NEDO-21052-A  
75NED53  
CLASS I  
MAY 1979

# MAXIMUM DISCHARGE RATE OF LIQUID-VAPOR MIXTURES FROM VESSELS

This approved version of report NEDO-21052 (September 1975) is being provided in accordance with the NRC's topical report program. This report NEDO-21052-A consists of the original text of NEDO-21052, the NRC staff letter accepting this report as a reference, the NRC staff Topical Report Evaluation and the supplementary information General Electric provided to the NRC staff during the review of NEDO-21052.

SUBJECT: REVIEW OF GENERAL ELECTRIC TOPICAL REPORT NEDO-21052,  
 "MAXIMUM DISCHARGE RATE OF LIQUID-VAPOR MIXTURES FROM  
 VESSELS"

FIG.2 SAFE-END SIDE BREAK FLOW

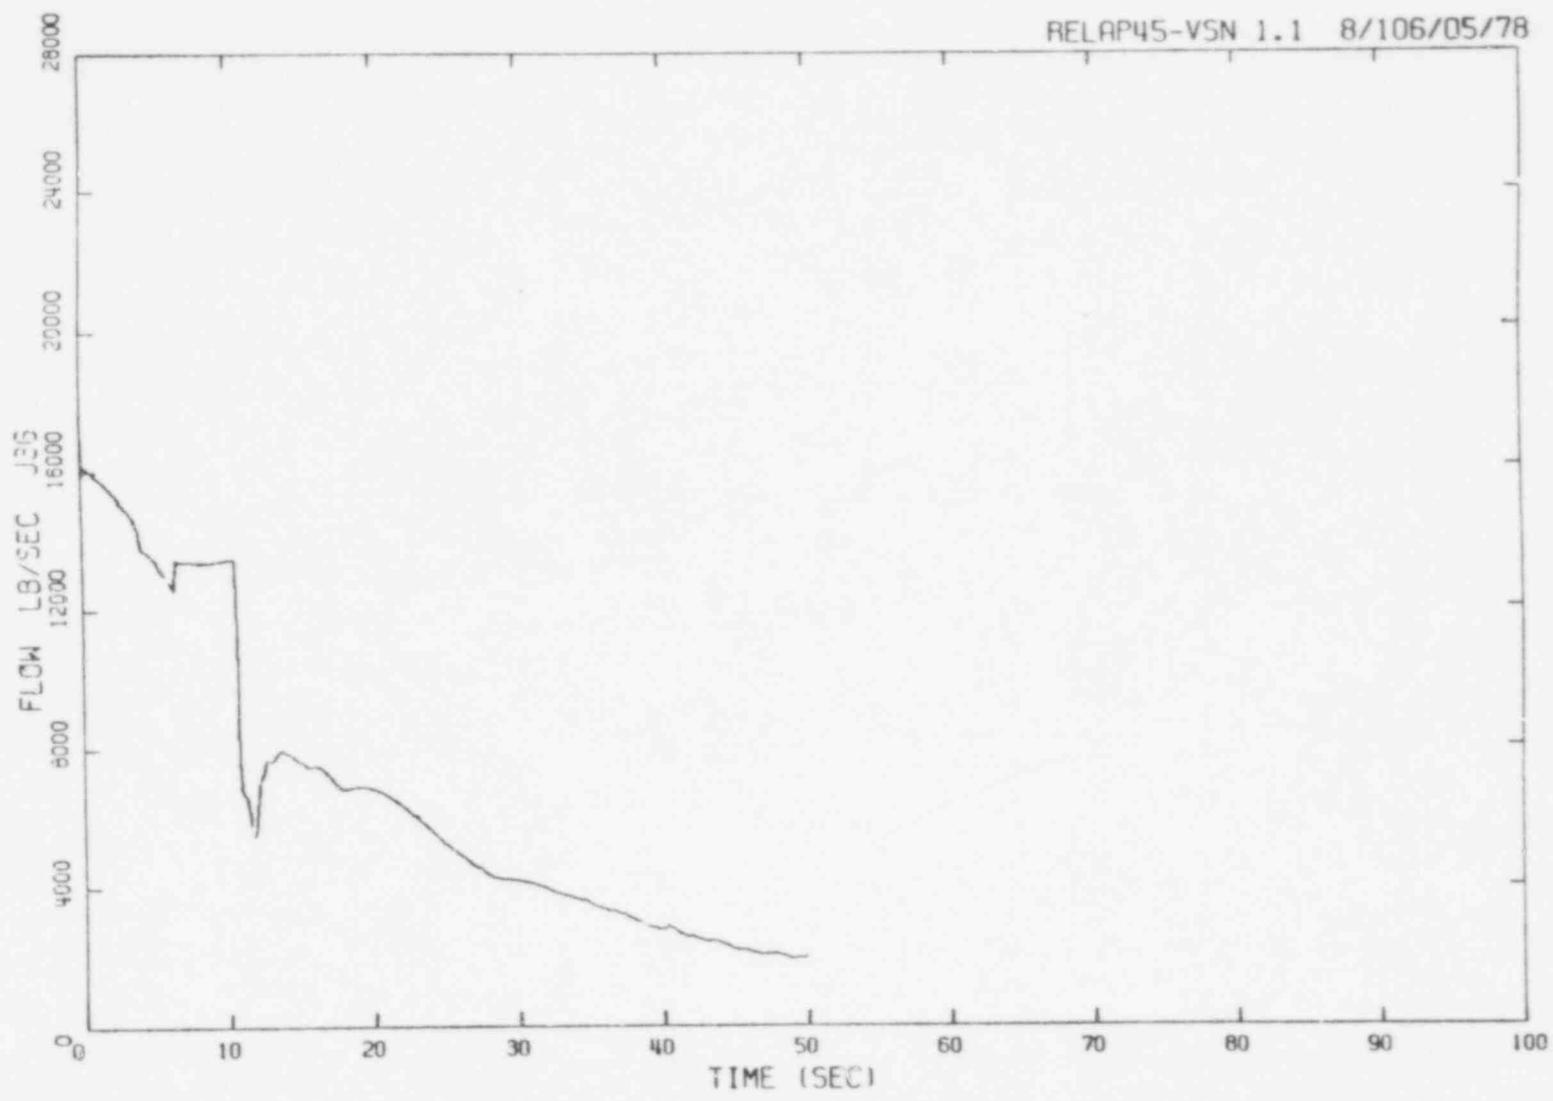
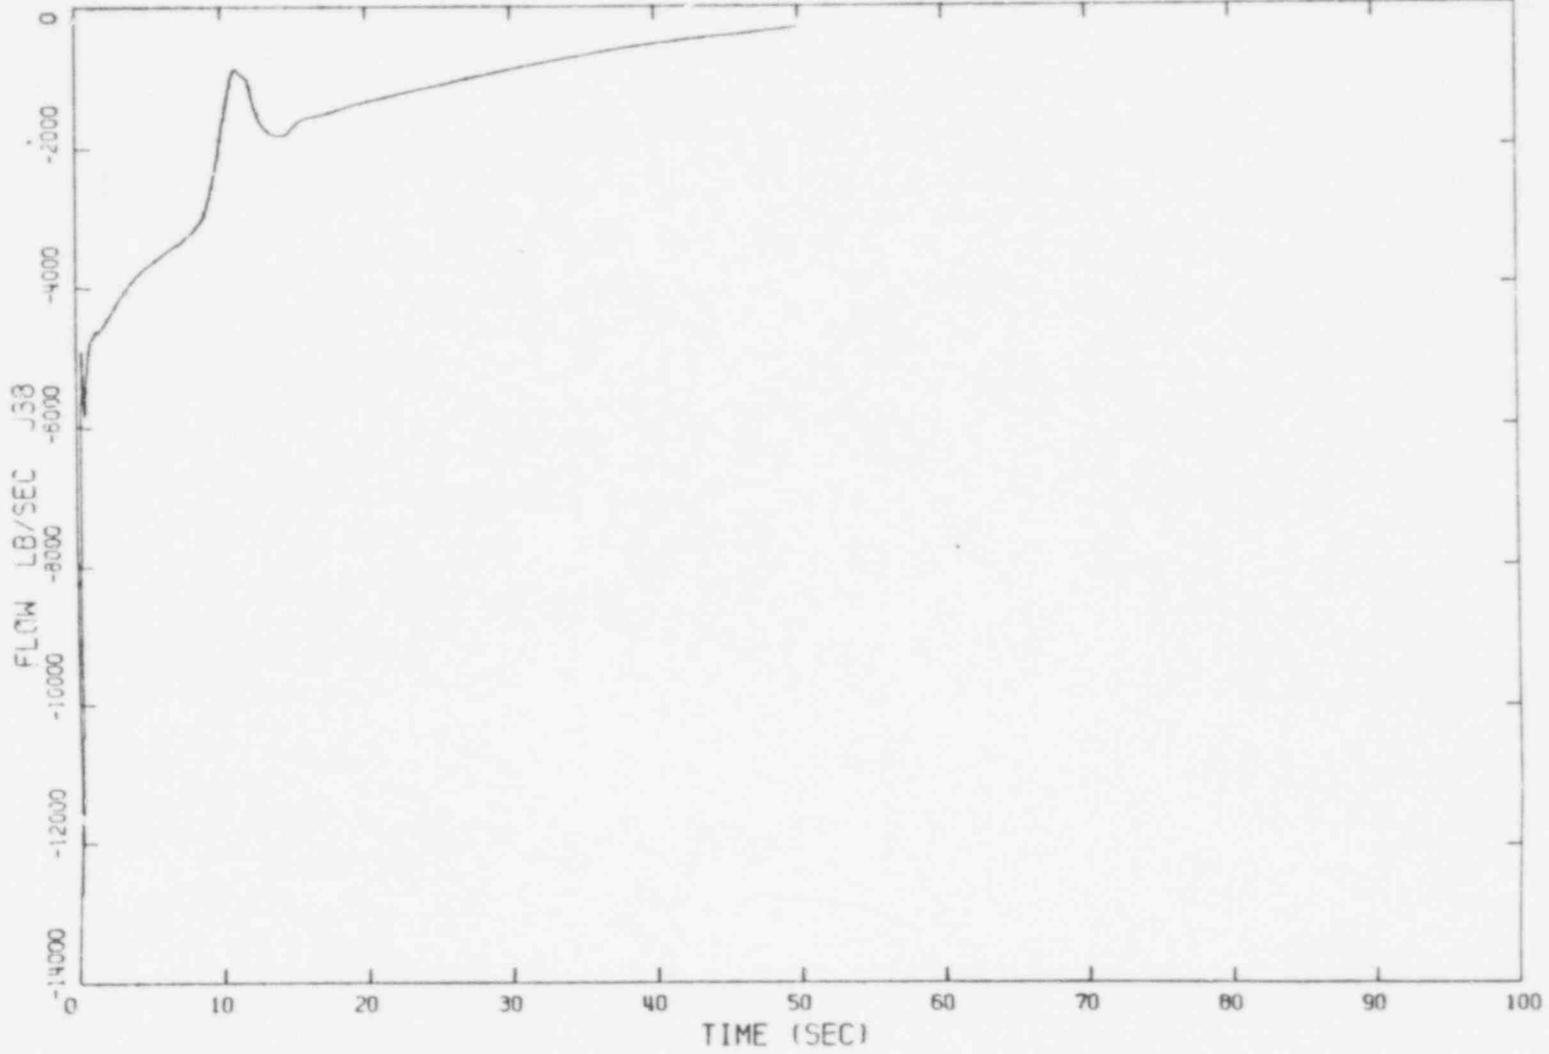
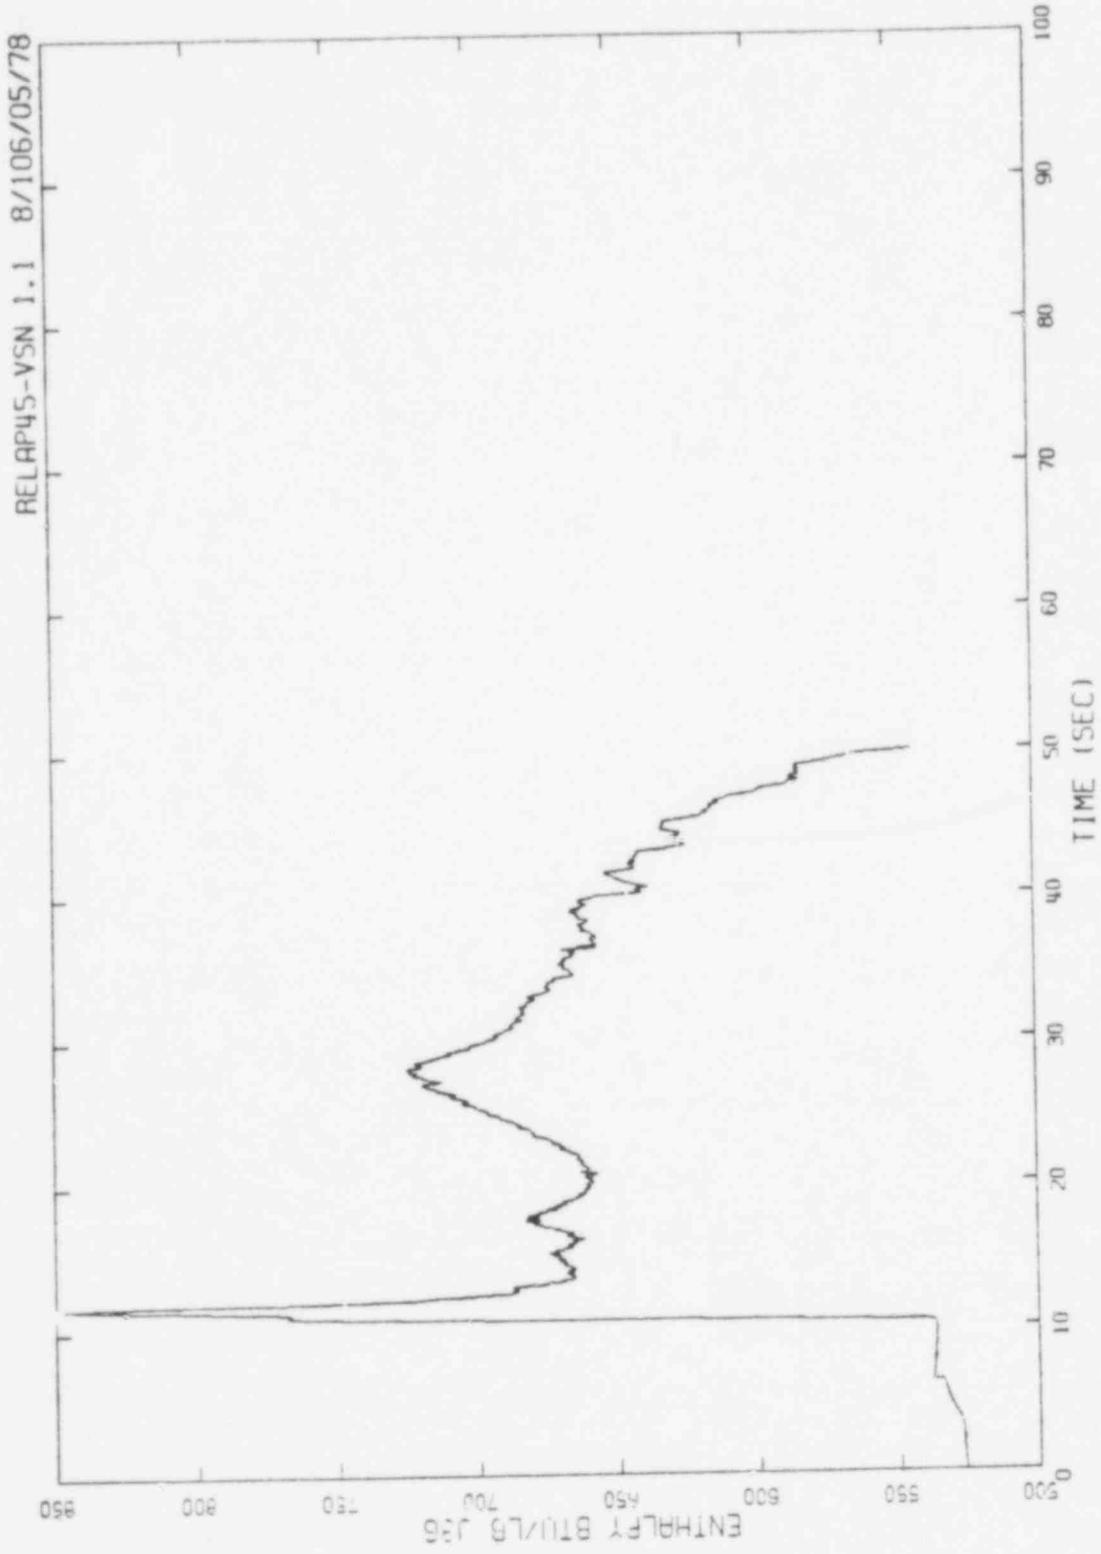
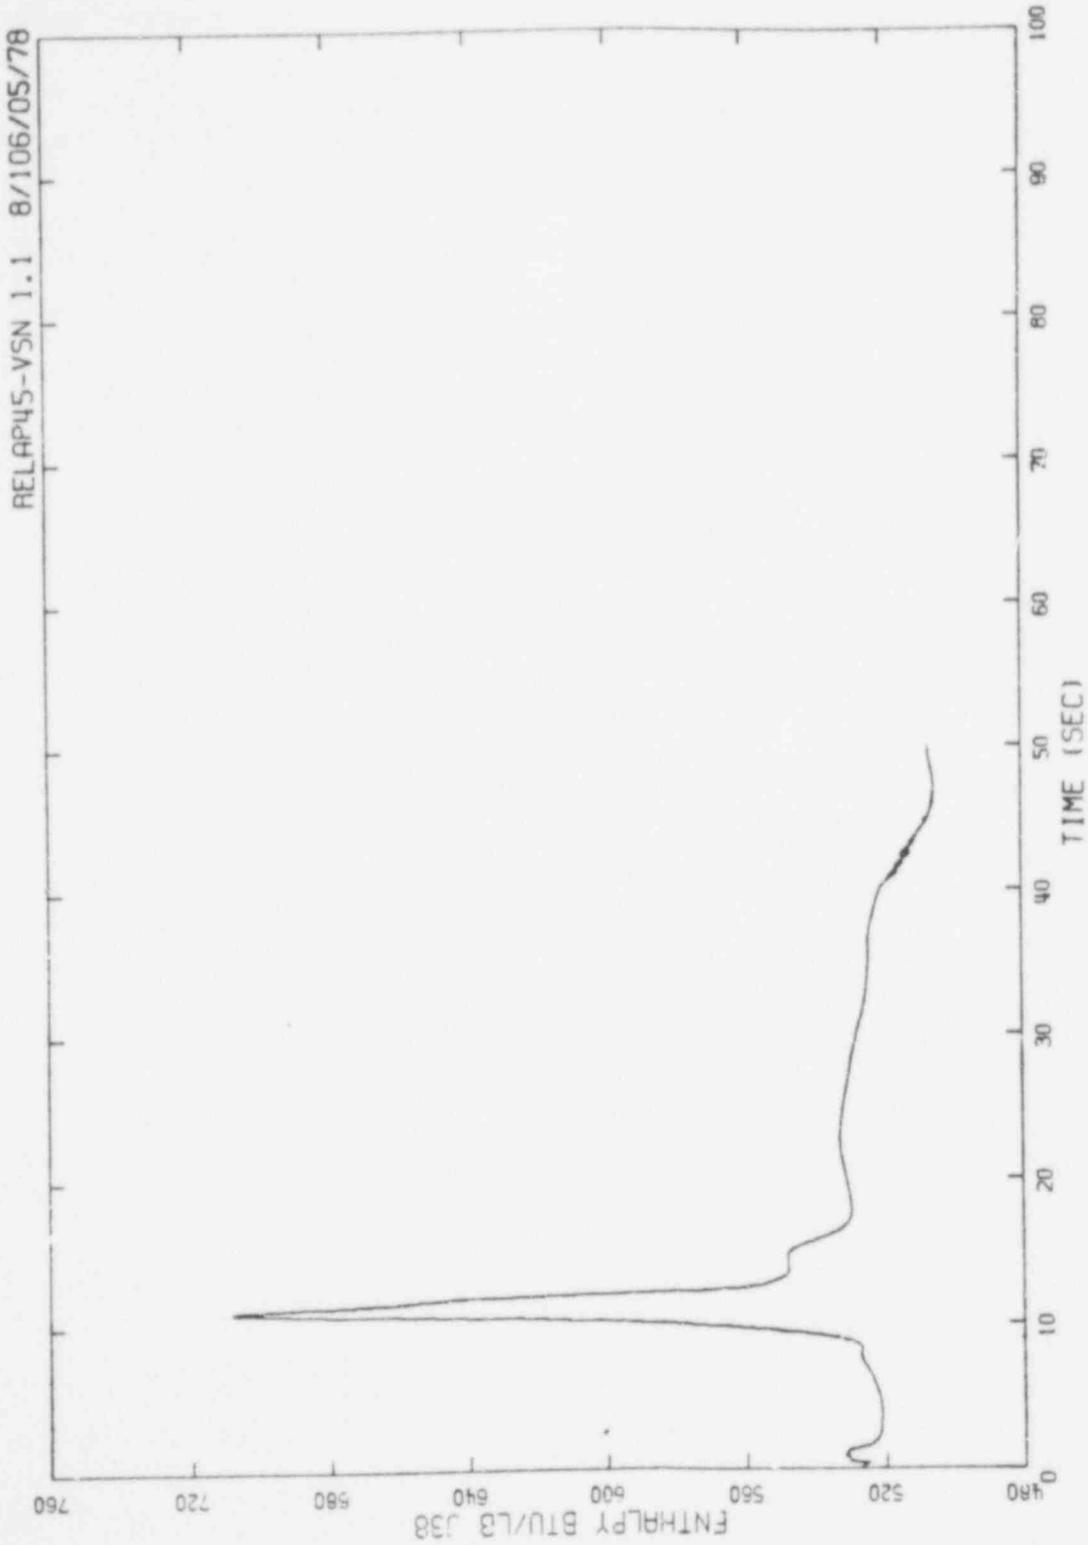
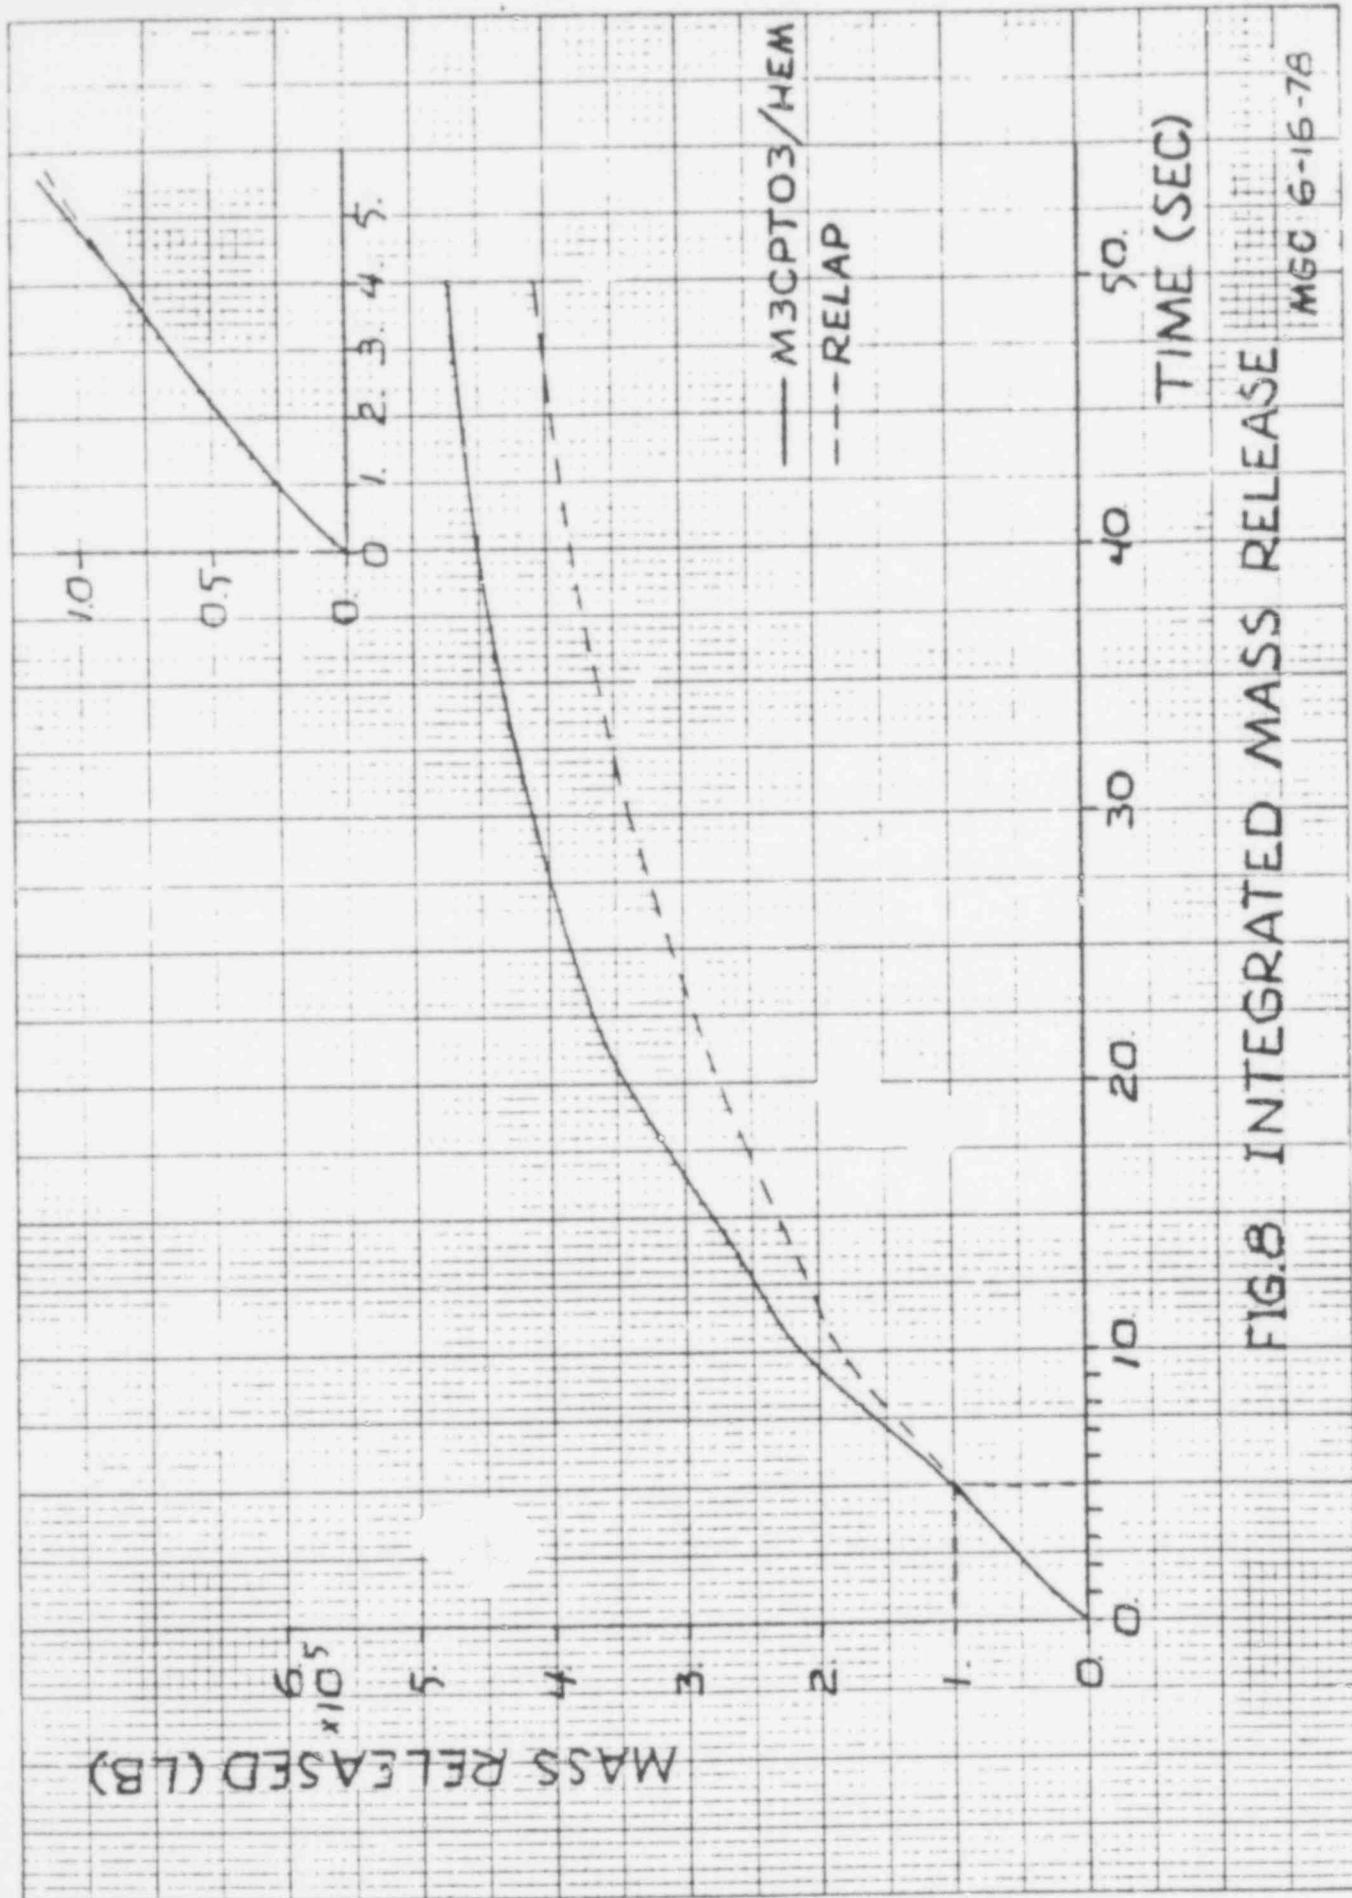
The mass release rates and the corresponding break fluid specific enthalpies given in Figures 2 through 5 for RELAP and given in Figures 6 and 7 for M3CPT03/HEM were integrated and the results are shown in Figures 8 and 9. The results show that the total energy release calculated by M3CPT03 is approximately 17 percent higher than the total energy release calculated by the RELAP code. The integrated mass release rates are  $4.71 \times 10^5$  lbm for M3CPT03 and  $4.08 \times 10^5$  lbm for RELAP. The energies that would be released to the primary containment over 50 seconds are  $2.84 \times 10^8$  BTUs for M3CPT03 and  $2.43 \times 10^8$  BTUs for RELAP.
